Subject: Specification of service life limitations for the brake hoses of the hydraulic wheel brake

Applicability: ASK 21; only models **ASK 21** und **ASK 21 Mi** Type-Certificate EASA.A.221; all serial numbers

Classification: Major Change

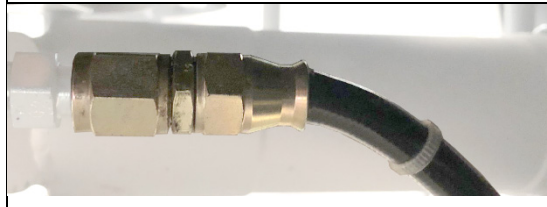
Brake hoses of the **old type** made from rubber material, identifiable by the shown fitting shape and the textile fabric wrapping of the hose.

Brake hoses of the **new type**, identifiable by the shown fitting shape.

Brake hoses of the **old type**: This brake hose has to be exchanged in regular intervals of 6 years. If the brake hose is in good condition, it is not necessary to exchange the hose. Operation on condition requires the inspection of the hose for proper condition at least every 100 h.

Brake hoses of the **new type**: This brake hose has no service life limitation (on condition).
